HISTORIC AND DESIGN REVIEW COMMISSION

October 05, 2016

HDRC CASE NO: 2016-378
ADDRESS: 110 GLORIETTA
LEGAL DESCRIPTION: NCB 576 BLK B E 9.45 FT OF 2 & W 29.55 FT OF 3 ARB A13
ZONING: RM4 H
CITY COUNCIL DIST.: 2
DISTRICT: Dignowity Hill Historic District
APPLICANT: Kyle Zochert
OWNER: Kyle Zochert
TYPE OF WORK: Porch and window fenestration modifications
REQUEST:

Porch Column Elevation Diagram

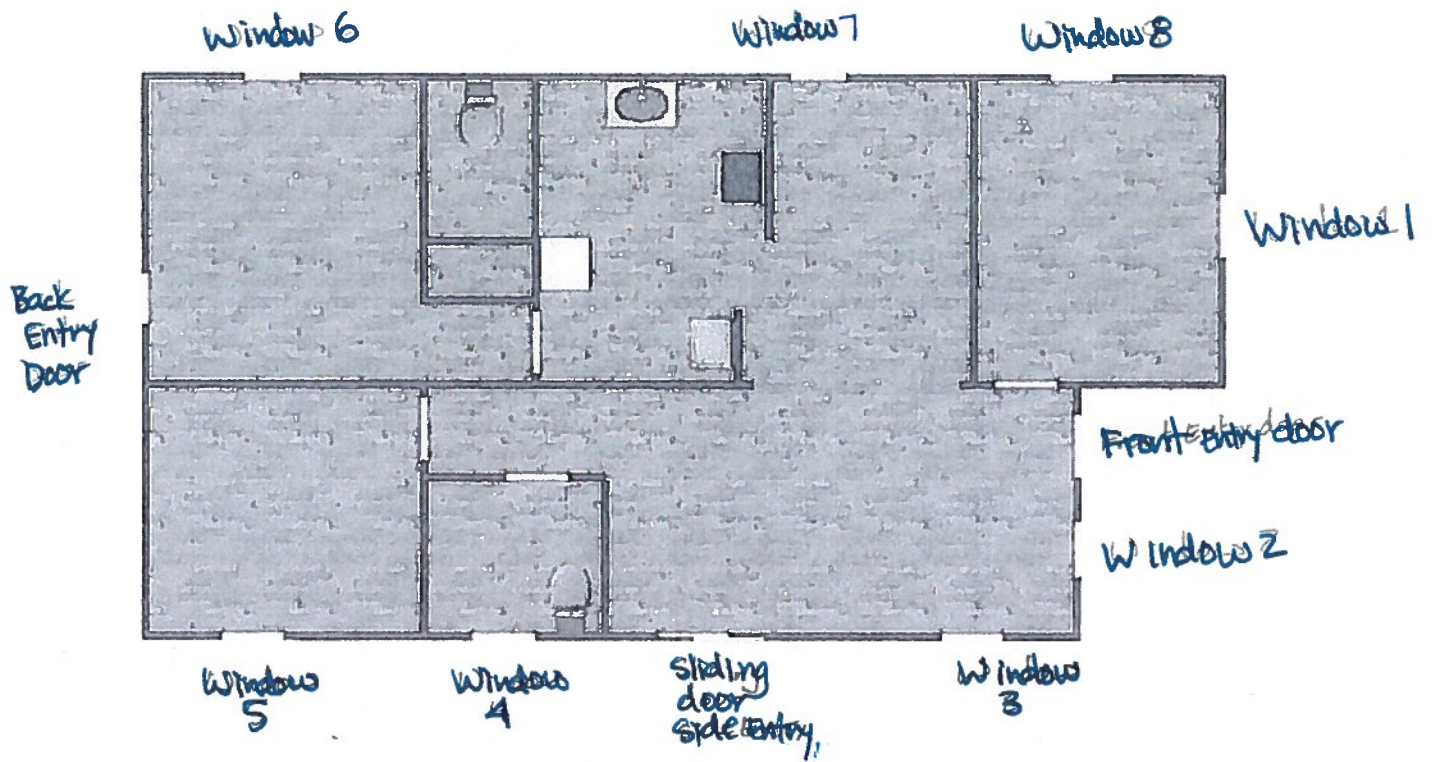
- j. FRONT PORCH POSTS - There are two existing 4"x4" wood posts under the front porch gable. The applicant is requesting to wrap the bottom of the existing original posts with wood to create a column base painted white. According to the Guidelines for Exterior Maintenance and Alterations 6.B.iv., new elements should be compatible with the architecture or style of the structure and not distract from the character of the building. Staff finds the proposal distracts from the simplicity of the architecture, thus not compatible with the home and not consistent with the Guidelines.

Staff recommends denial of item #3 and 4 based on finding i and j.

EXISTING CONDITIONS
Previous
Window/Door Layout

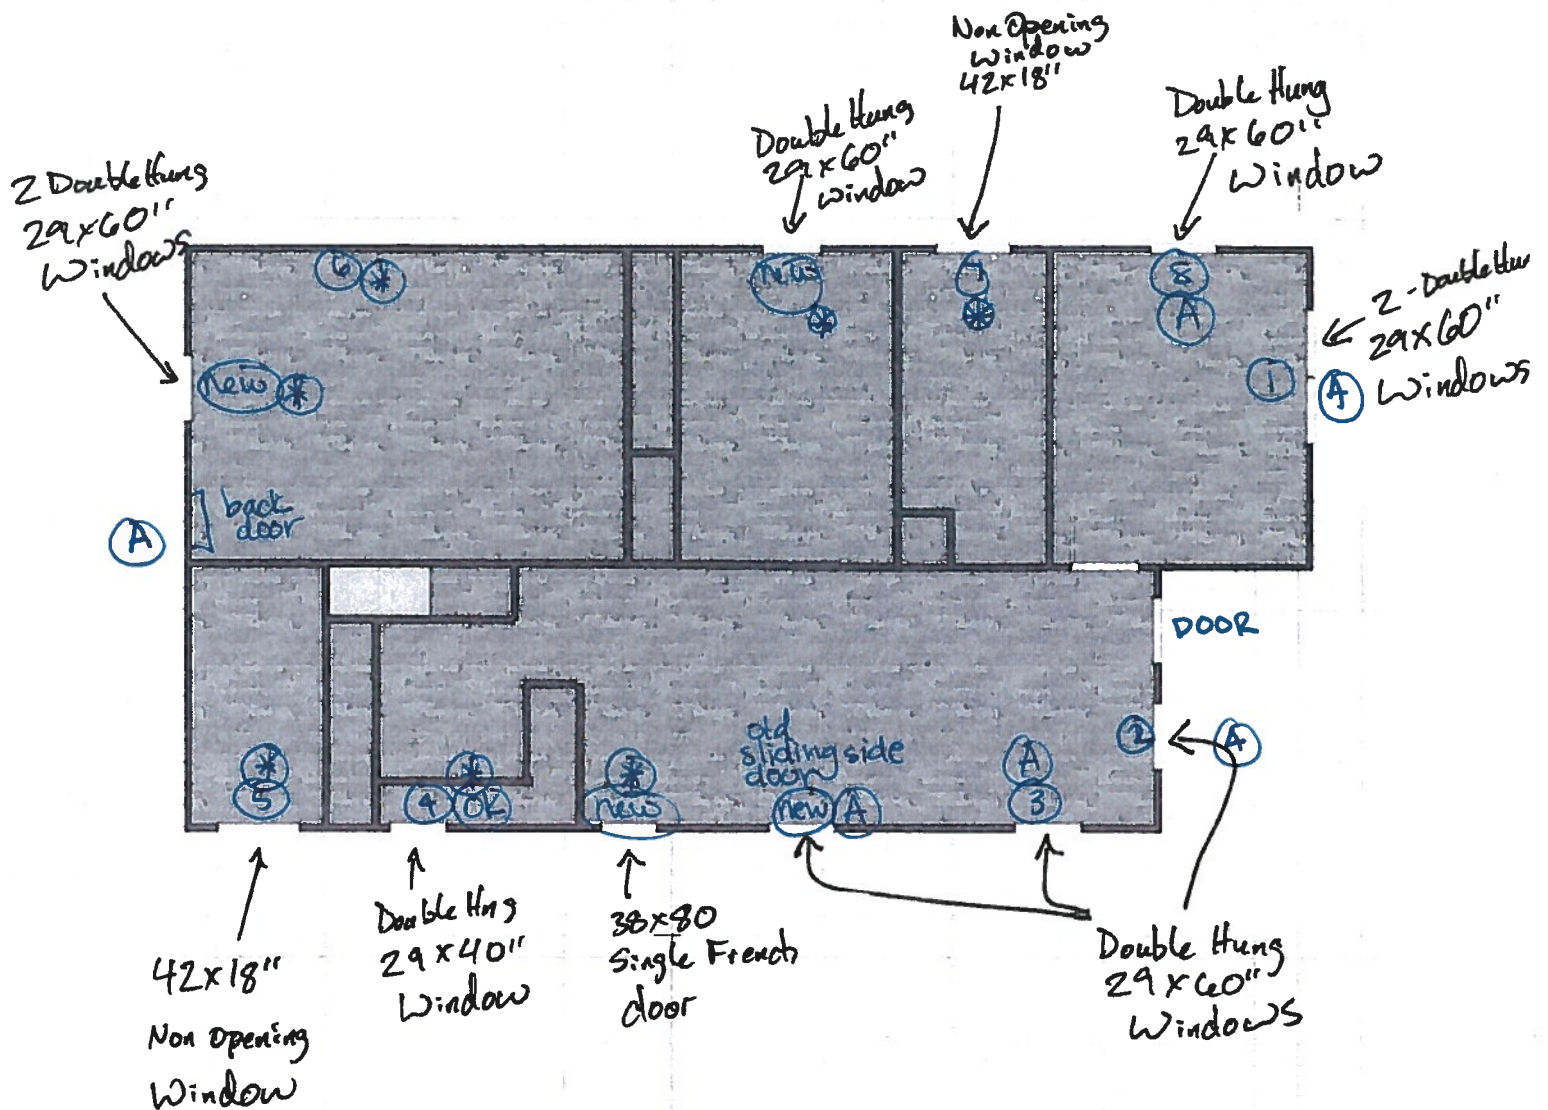
- b. Work was done on the windows prior to approval. The applicant has submitted the required documentation and the fees have been paid.
- c. NEW OPENINGS - There are 4 existing openings on the left elevation: three windows and one sliding glass door. The rear elevation includes a non-historic back door opening. The right elevation includes 3 window openings. The applicant is proposing at this time to create 3 new window openings: a one over one wood window on the left elevation, a double one over one wood window on the rear elevation, and a horizontal 42" x 18" wood window on the right elevation. According to the Guidelines for Exterior Maintenance and Alterations 6.B.ii., new entrances are compatible in size, scale, shape proportion, material and massing with historic entrances. Staff finds the proposed openings on the left and rear consistent with the Guidelines, but finds the horizontal window not appropriate for the architectural style.

1. That the new opening installed on the right elevation be a one over one window as noted in finding c.
2. That the window to be installed on the left toward the rear be a one over one window as noted in finding f.

110 Glorietta
Left Side Elevation
Old Layout

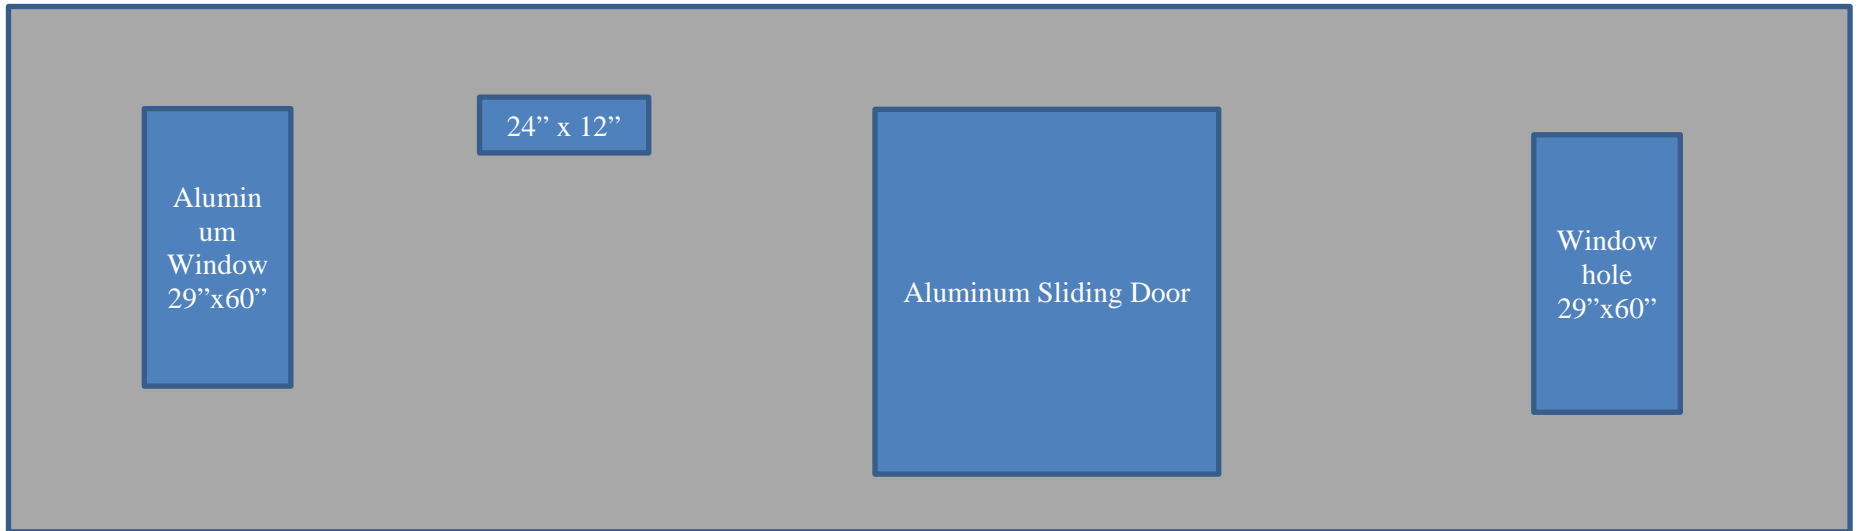
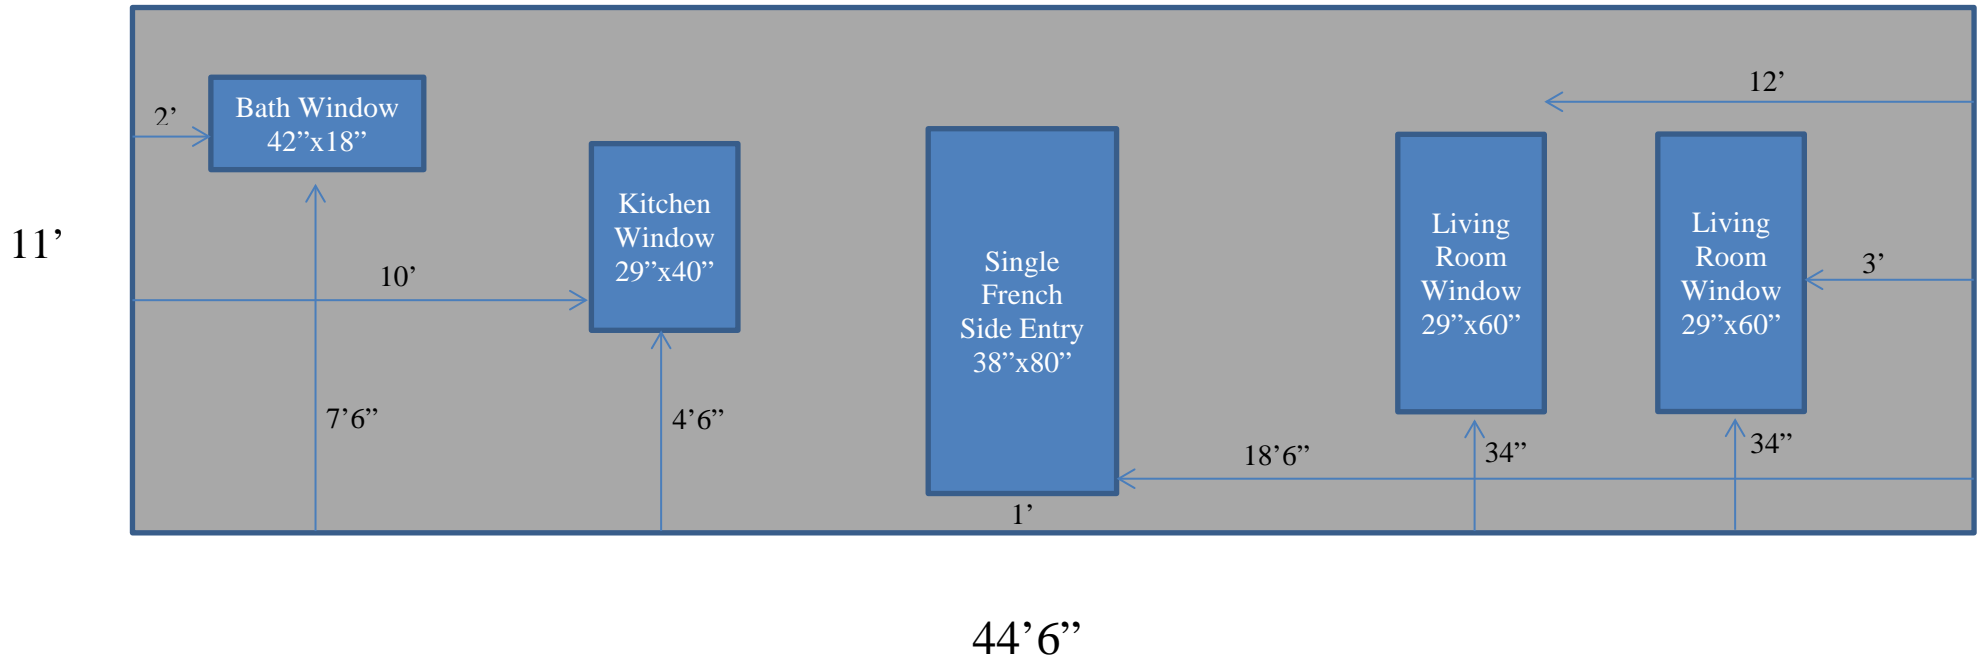
- d. ALTER WINDOW OPENING - There is an existing aluminum sliding glass door on the left elevation. The applicant is proposing to remove the door and install a wood single French door in its place. According to the Guidelines for Exterior Maintenance and Alterations 6.B.vii., non-historic incompatible windows should be replaced with windows that are typical of the architectural style. Staff finds the proposal consistent with the Guidelines.

- e. ALTER WINDOW OPENING - There is an existing aluminum horizontal 24" x 12" window on the left elevation to the left of the existing sliding aluminum door. The applicant is proposing to remove the window and install a wood one over one window in its place. According to the Guidelines for Exterior Maintenance and Alterations 6.B.vii., non-historic incompatible windows should be replaced with windows that are typical of the architectural style. Staff finds the proposal consistent with the Guidelines.

- f. ALTER WINDOW OPENING - There is an existing aluminum one over one window on the left elevation toward the rear. The applicant is proposing to remove the window and install a horizontal 42" x 18" wood window. According to the Guidelines for Exterior Maintenance and Alterations 6.B.vii., non-historic incompatible windows should be replaced with windows that are typical of the architectural style, and that window openings should be preserved. Staff finds the proposal to remove the aluminum window and replace with wood appropriate, but finds the proposal to alter the window opening and the proposed proportion not appropriate for the bungalow style home. Staff finds an appropriate window proportion would be vertical one over one.

110 Glorietta
Right Side Elevation
Old Layout

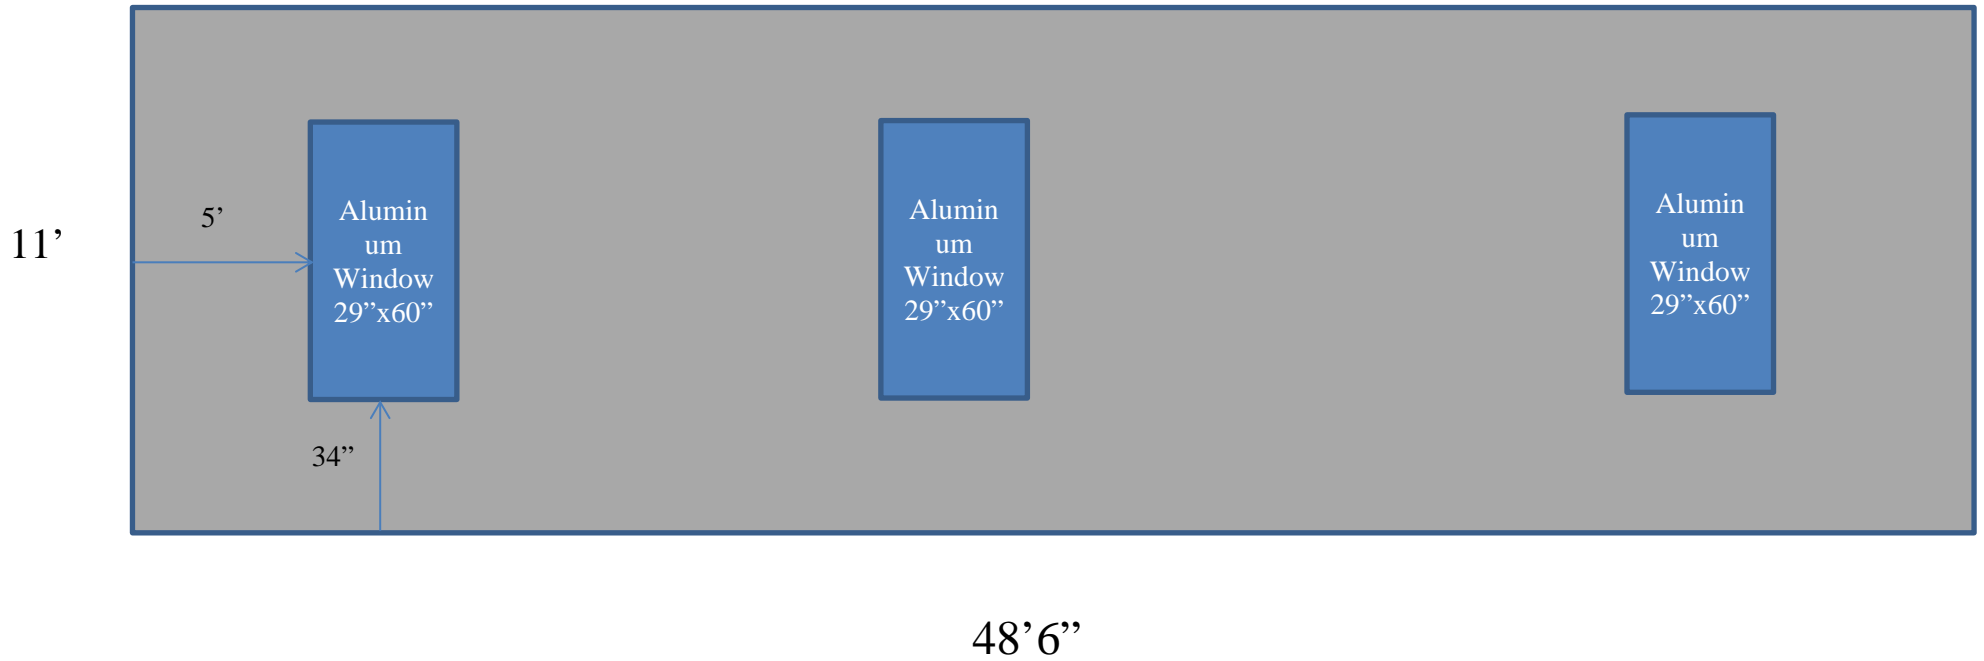
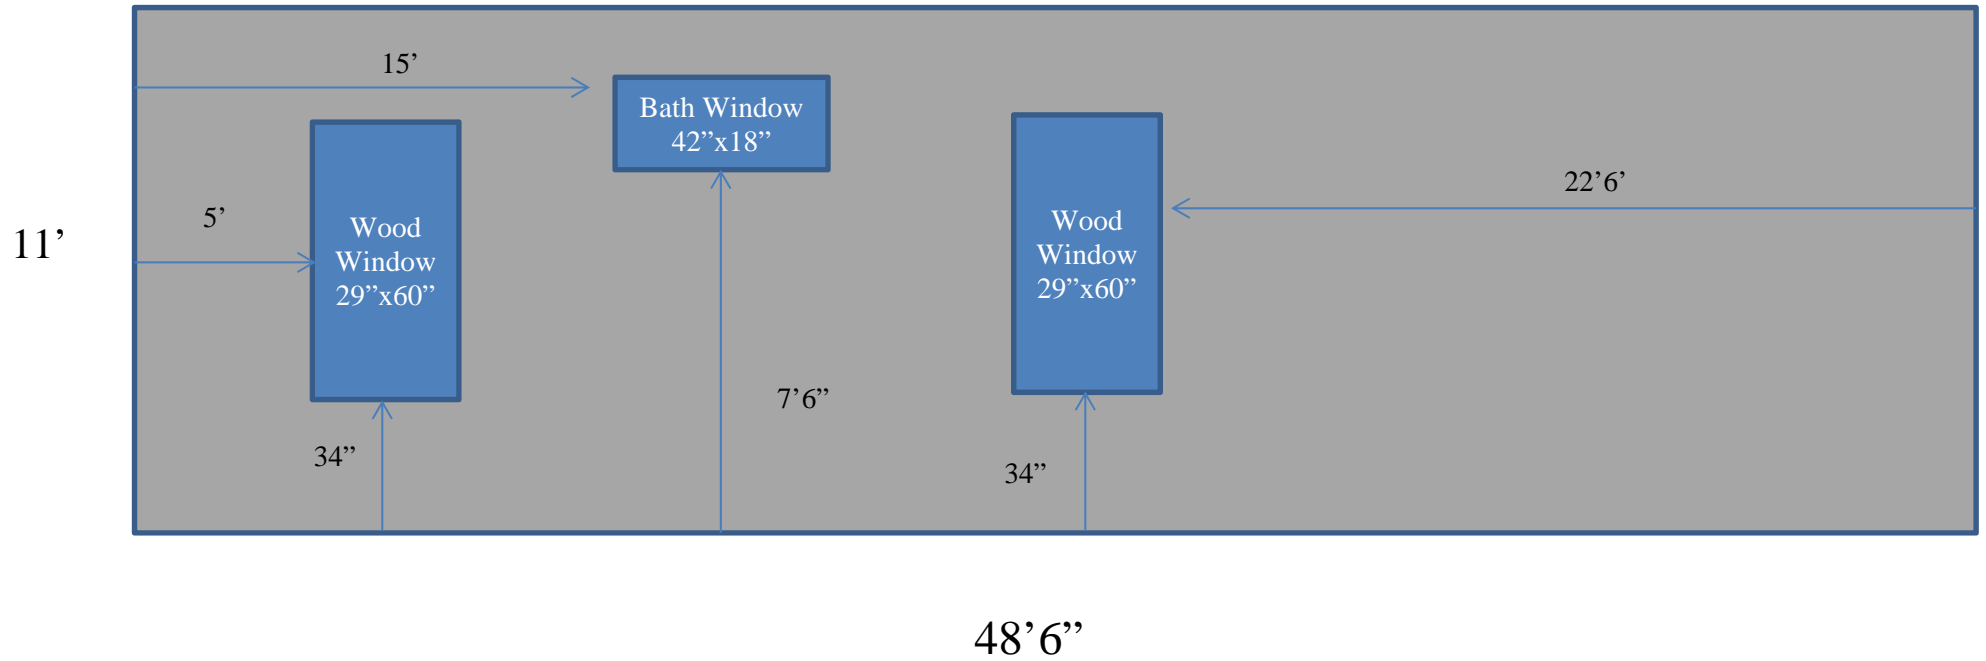
- g. ALTER WINDOW OPENING - There is an existing aluminum one over one window on the right elevation toward the rear. The applicant is proposing to remove the window and fill in the opening. According to the Guidelines for Exterior Maintenance and Alterations 6.A.i., original window openings should be preserved. Staff finds the proposal to infill the window not consistent with the Guidelines. Staff recommends the window opening be retained.

- h. ALTER WINDOW OPENING - There is an existing aluminum one over one window on the right elevation. The applicant is proposing to shift the opening to the right of the existing, historic opening. According to the Guidelines for Exterior Maintenance and Alterations 6.A.i., original window openings should be preserved. Staff finds the proposal to alter the original opening not consistent with the Guidelines. Staff recommends the opening be retained.

3. That the window opening on the right toward the rear be retained as noted in finding g.
4. That the window opening be retained as noted in finding h.
